**FINAL ENGINEERING PLANS  
FOR  
SUMMIT HOUSING GROUP - PUBLIC IMPROVEMENTS**

LYONS VALLEY PARK FILING NO. 8

**COVER SHEET  
SUMMIT HOUSING GROUP  
LYONS VALLEY PARK FILING NO. 8  
LYONS, COLORADO**

STORM SEWER PLAN AND PROFILE  
SUMMIT HOUSING GROUP  
LYONS VALLEY PARK FILING NO. 8  
LYONS, COLORADO

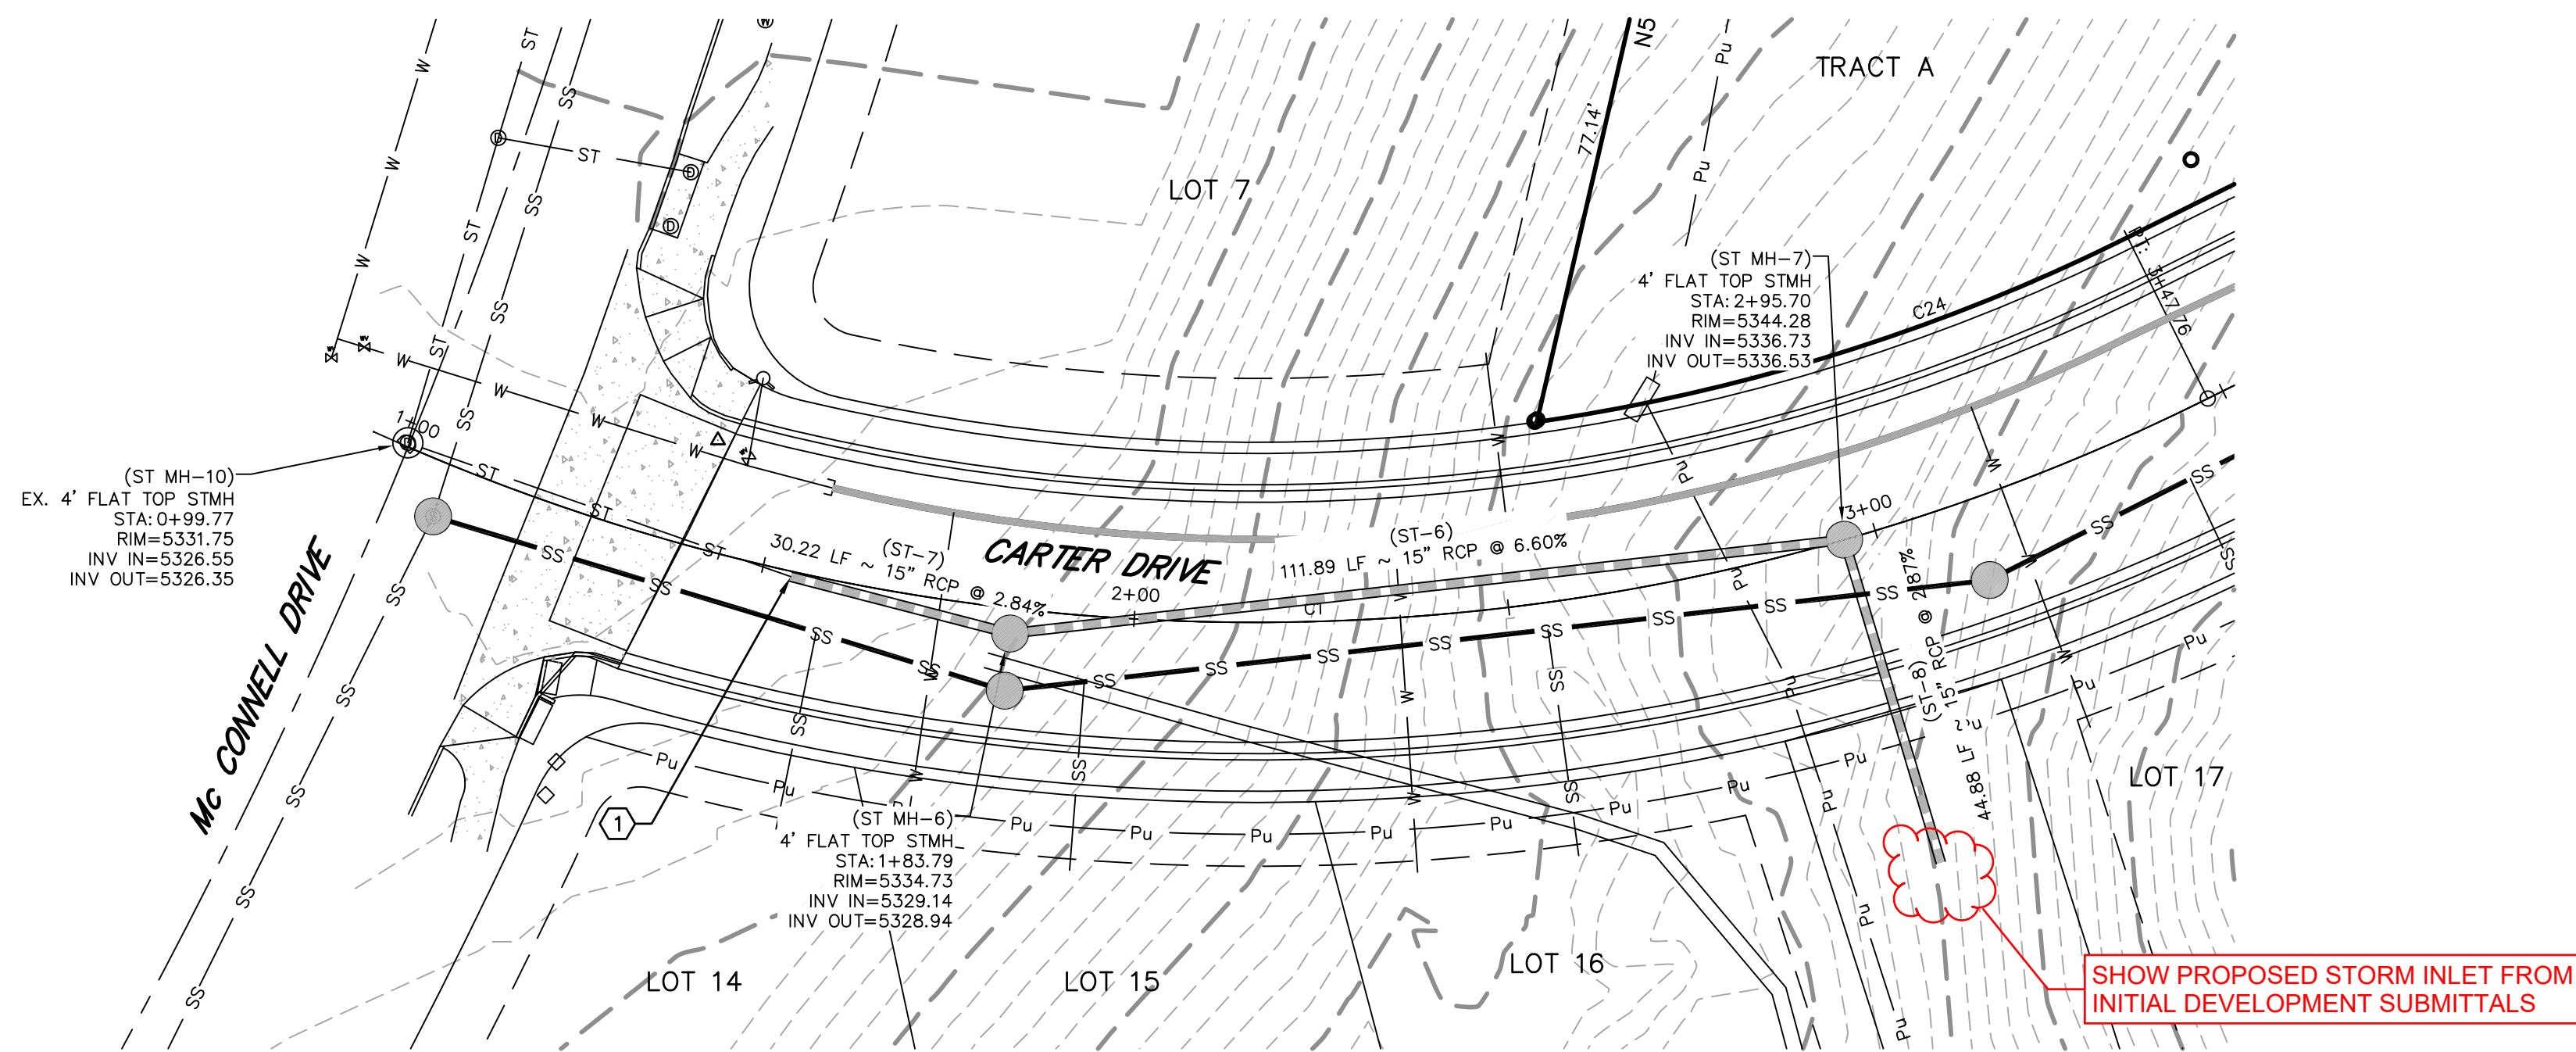
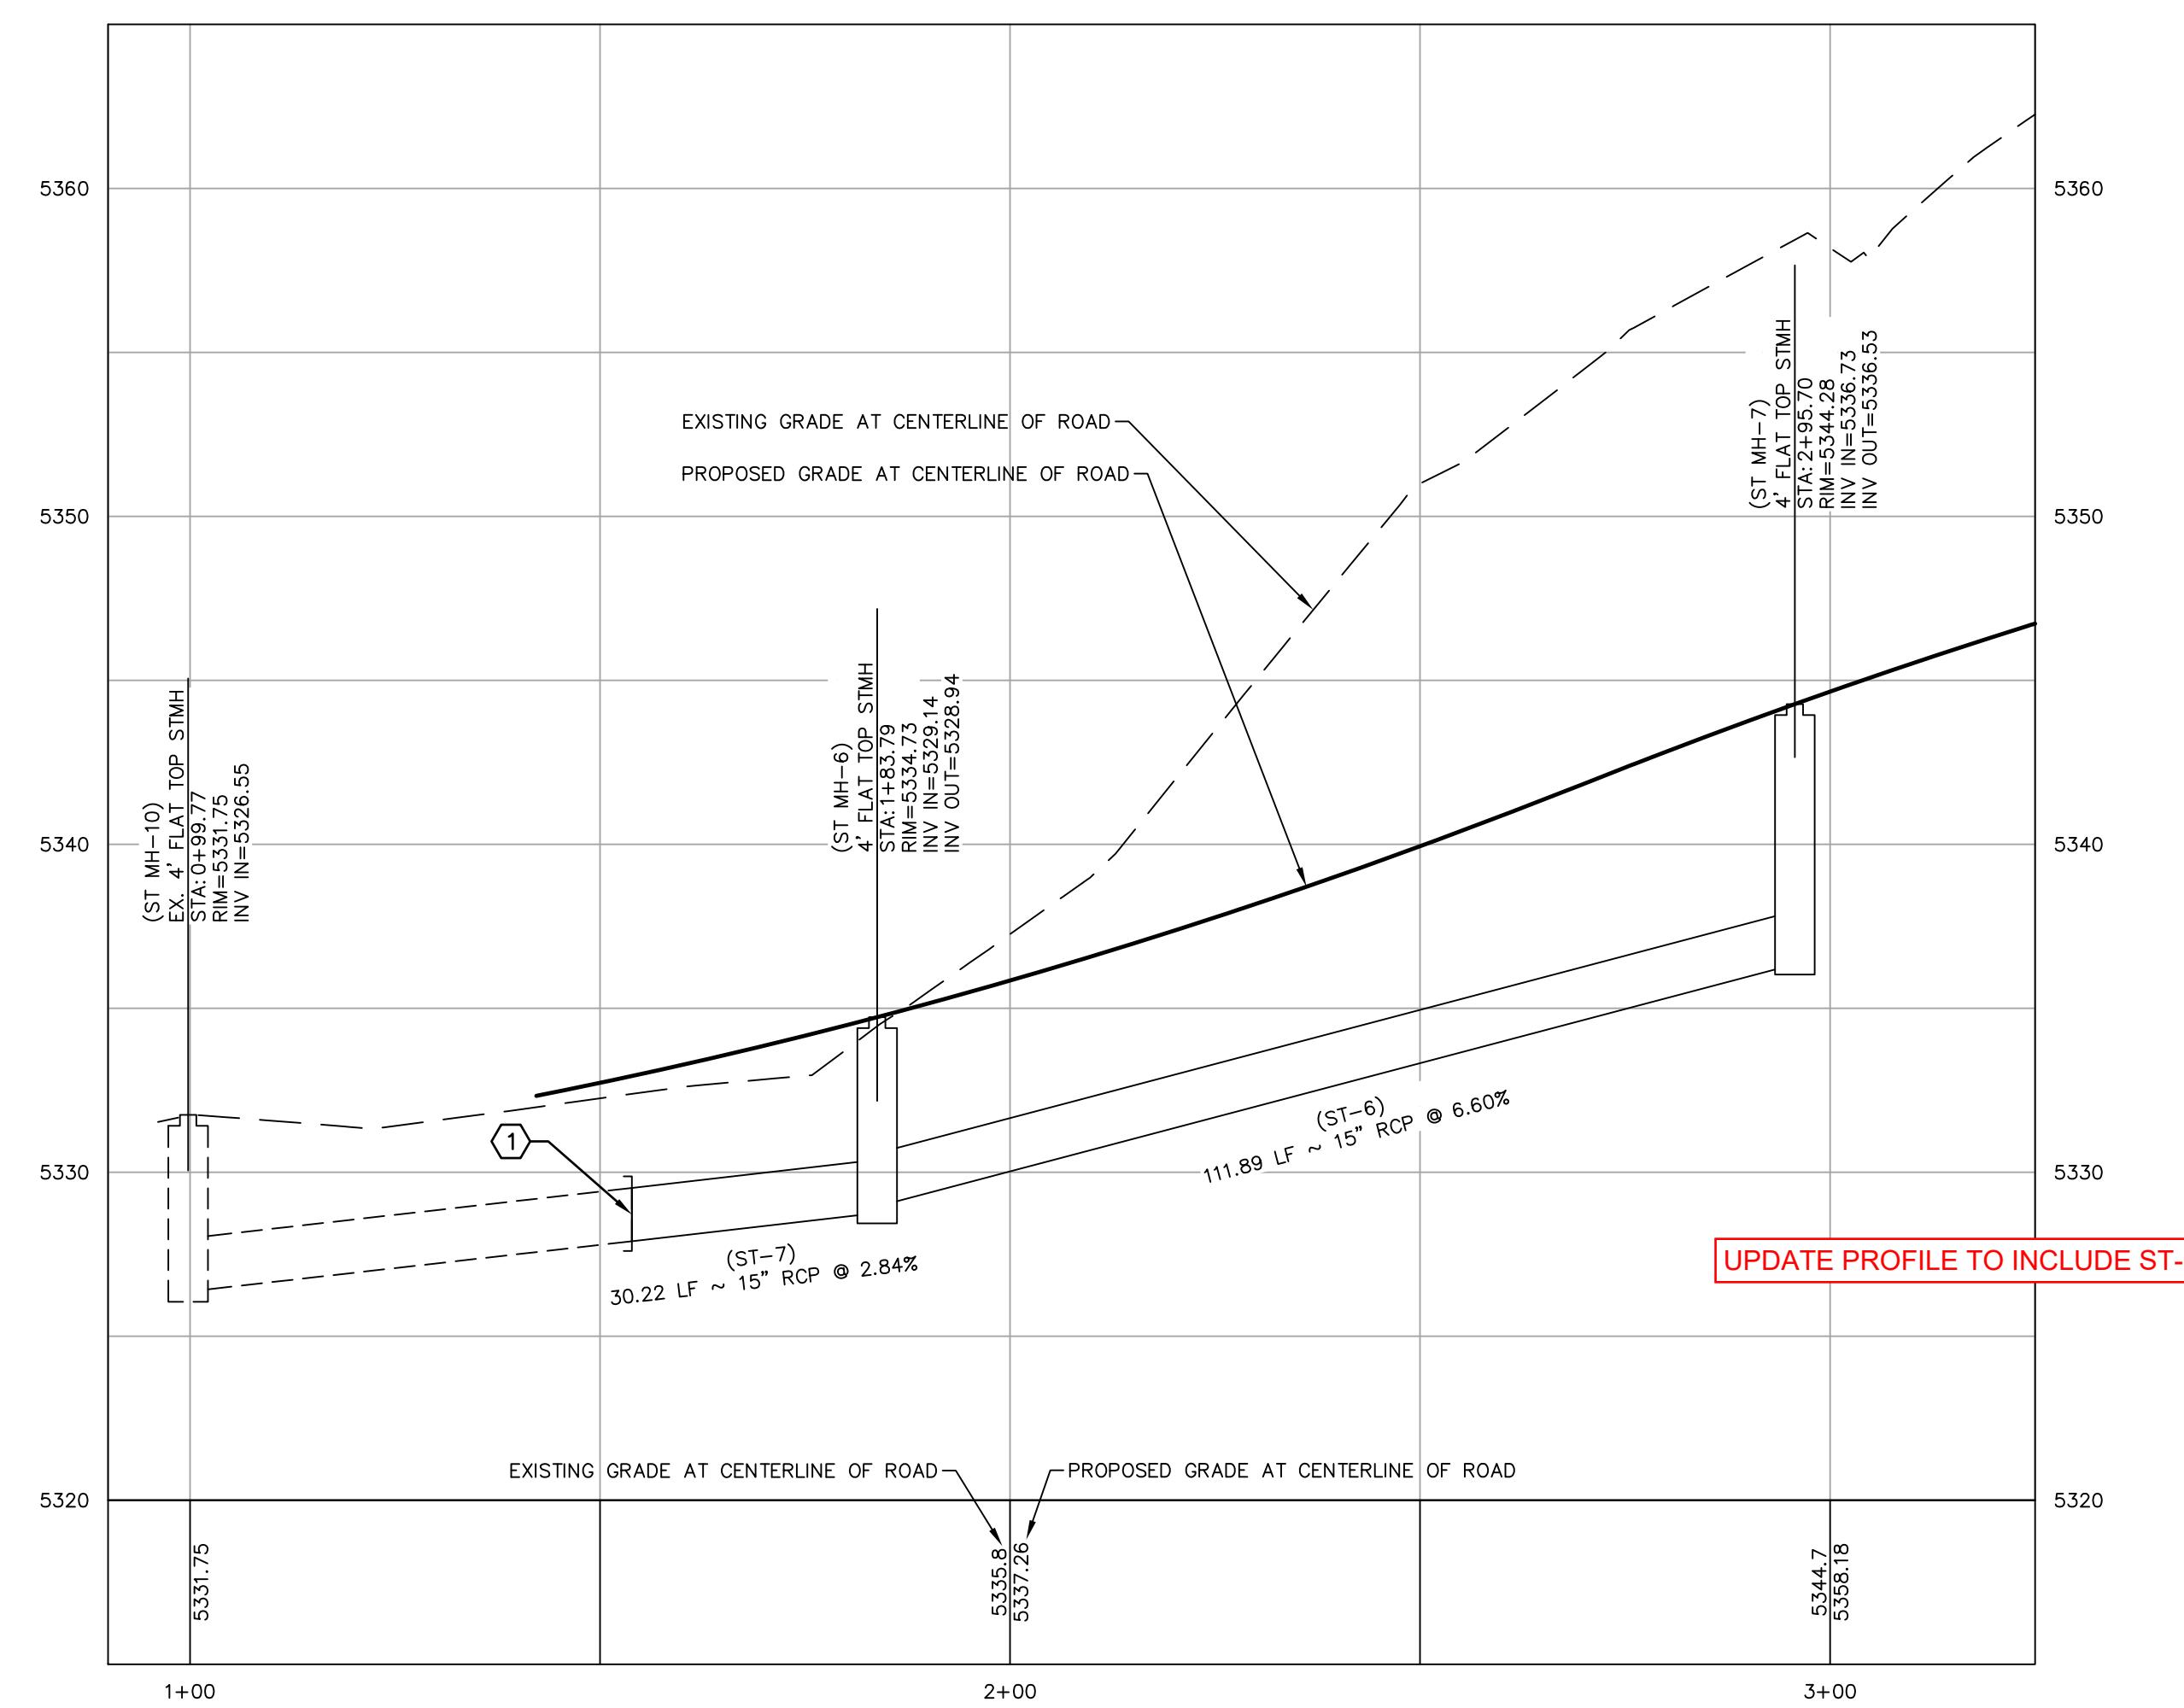
## SHOW PROPOSED STORM INLET FROM INITIAL DEVELOPMENT SUBMITTALS

CARTER DRIVE  
ROAD PLAN AND PROFILE  
SUMMIT HOUSING GROUP  
LYONS VALLEY PARK FILING NO. 8  
LYONS, COLORADO

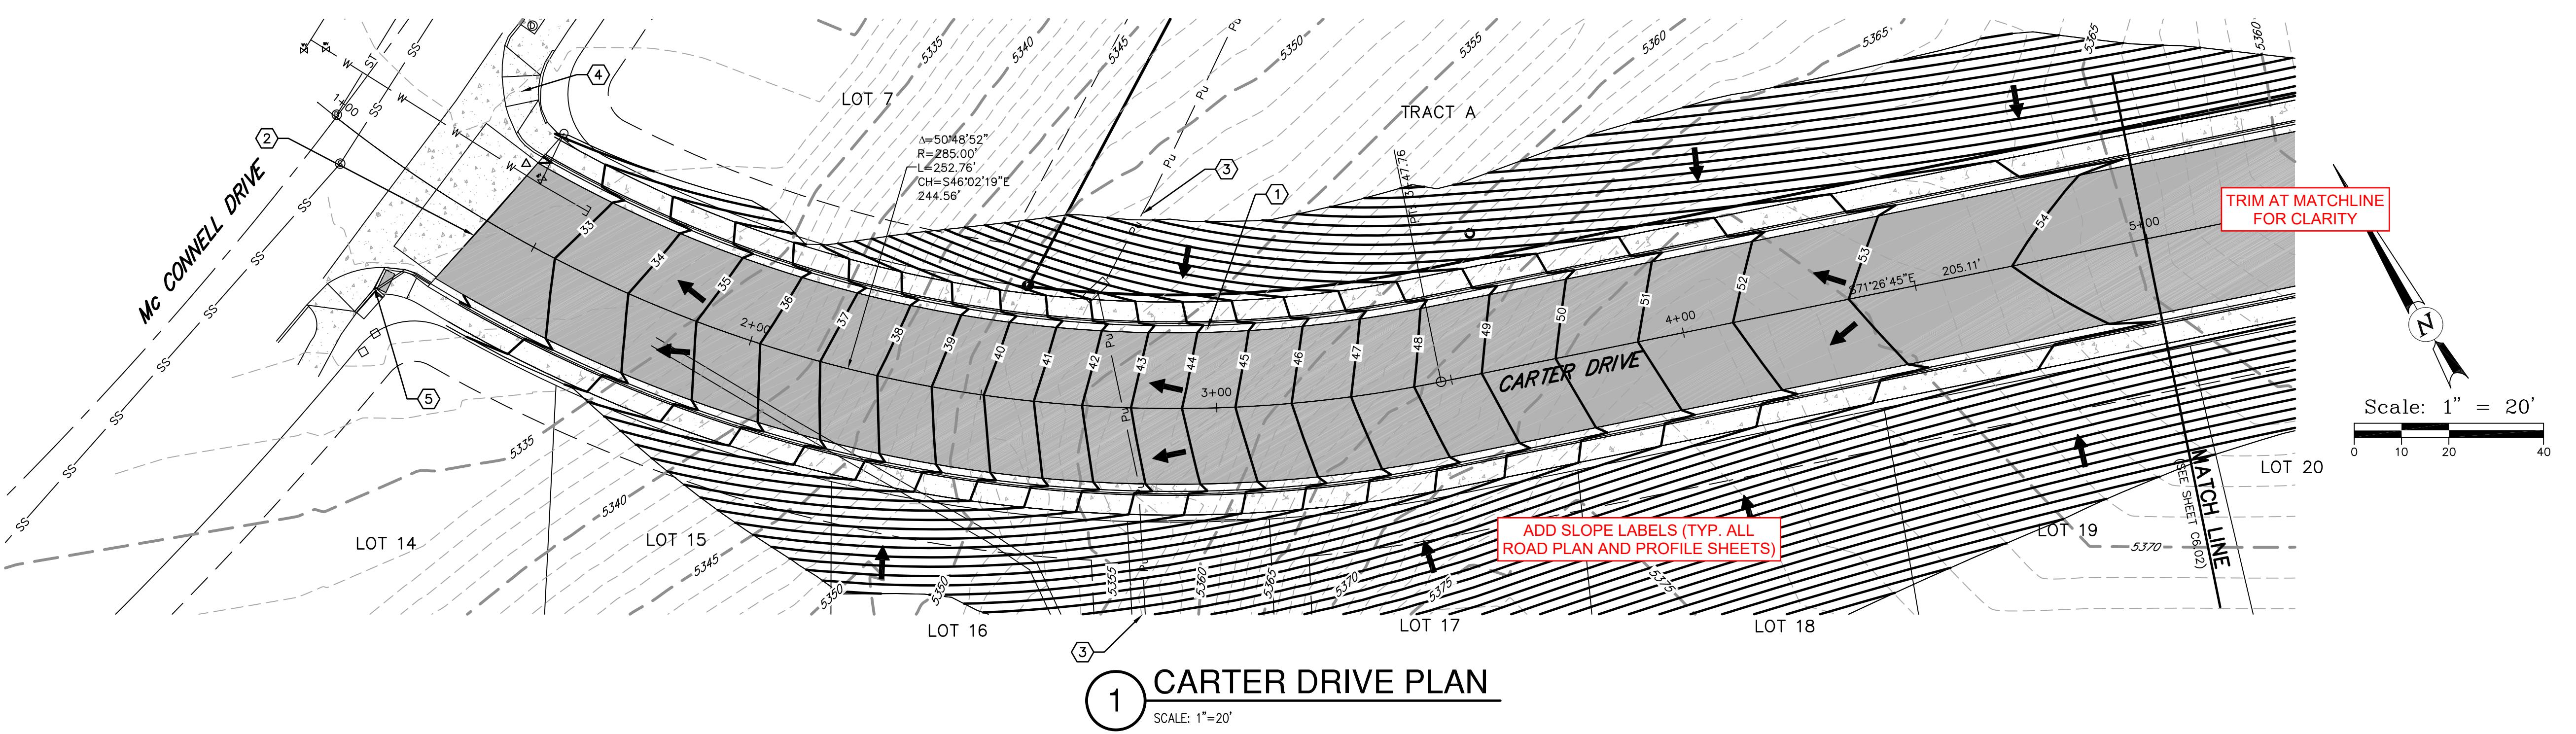
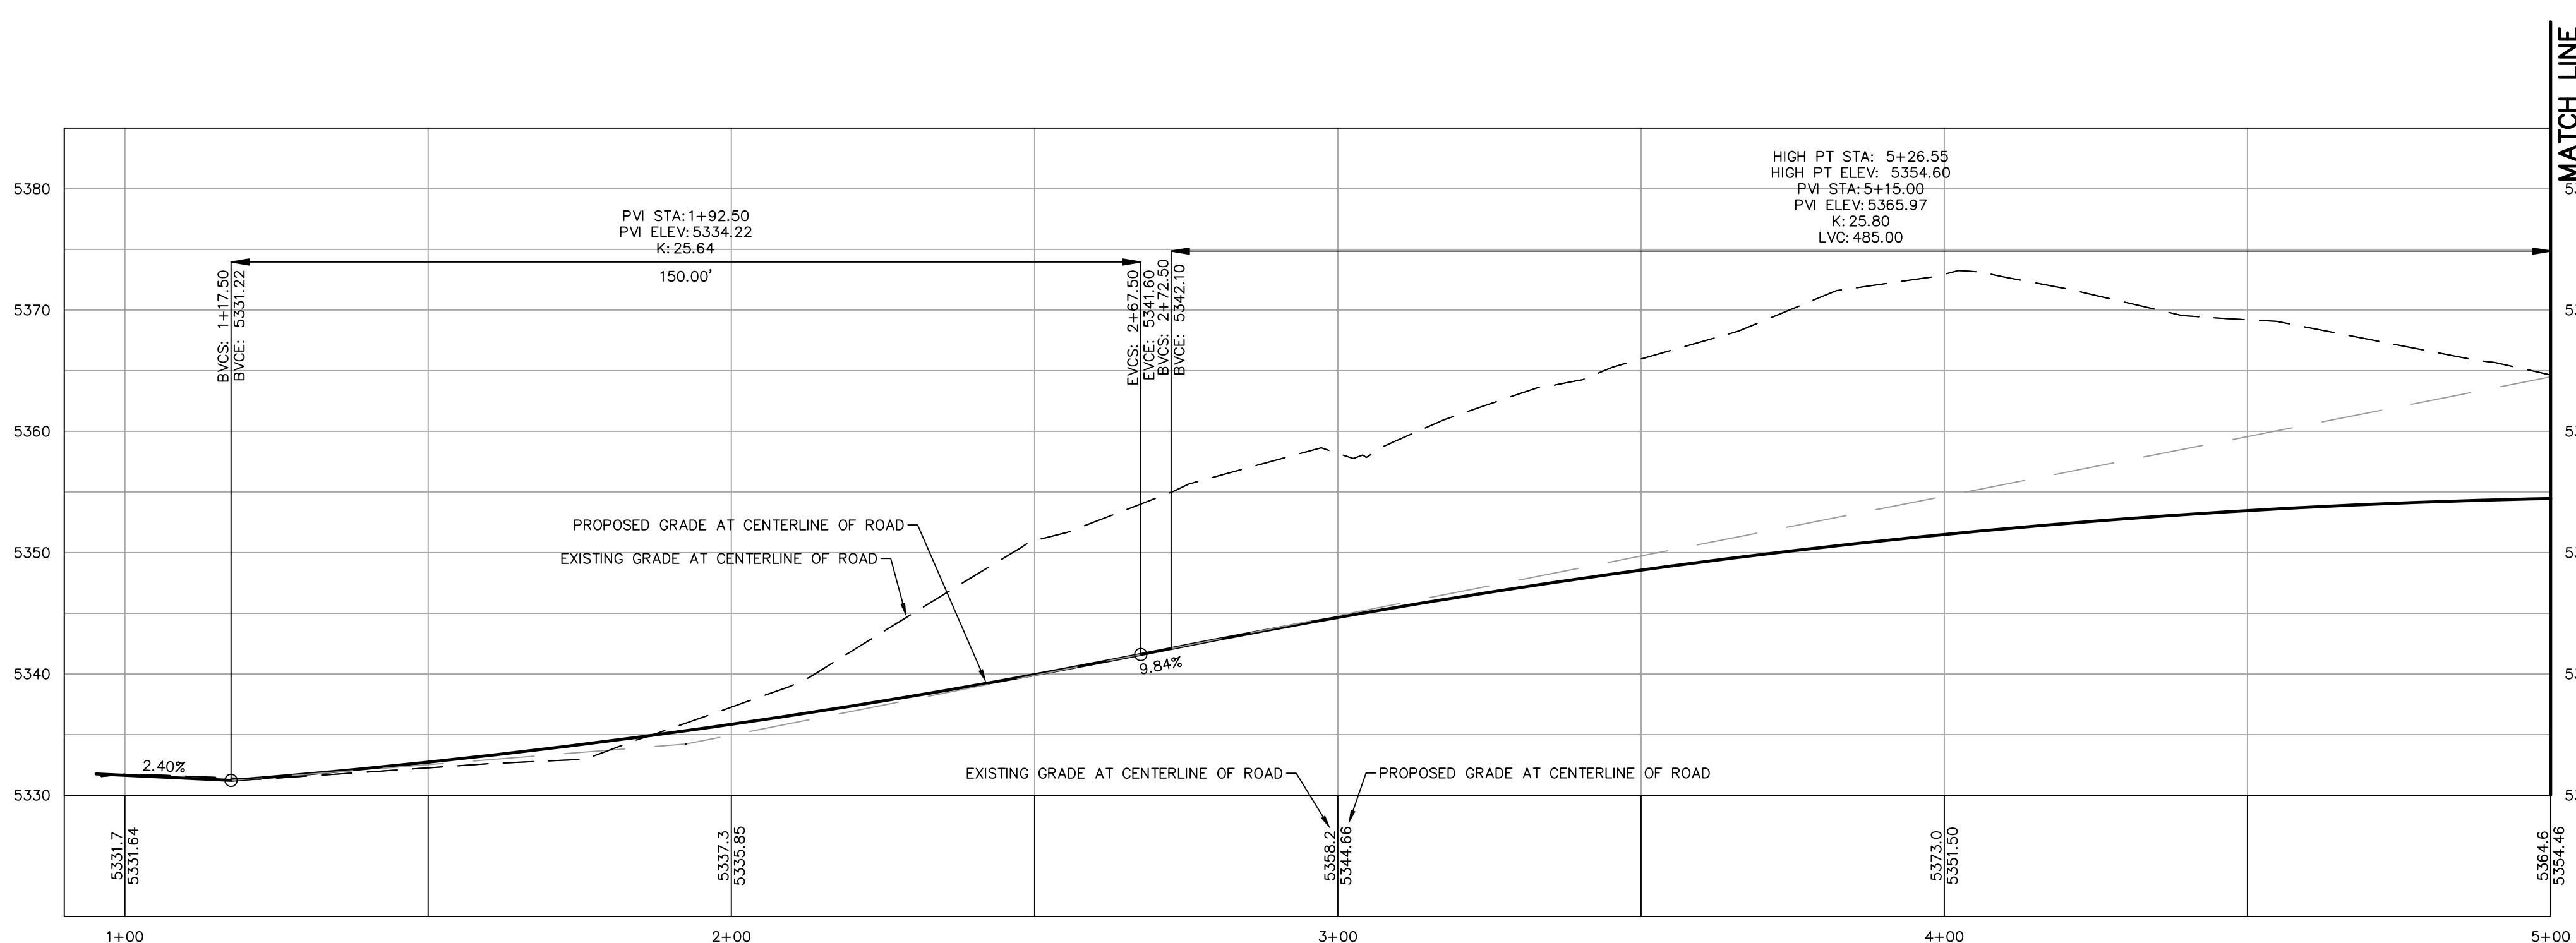
TRIM AT MATCHLINE  
FOR CLARITY

**ADD SLOPE LABELS (TYP. ALL  
ROAD PLAN AND PROFILE SHEET)**

PLEASE INDICATE WHAT TRAFFIC CONTROL MEASURES WILL BE USED TO DETER REGULAR TRAFFIC WHILE ALLOWING EMERGENCY TRAFFIC TO USE THE GRAVEL EMERGENCY SECTION OF CARTER DRIVE.

PLEASE ADD SIGNAGE ACCORDING TO THE TOWN OF LYONS DESIGN CRITERIA SECTION 3.1.3.2 - SIGNS.
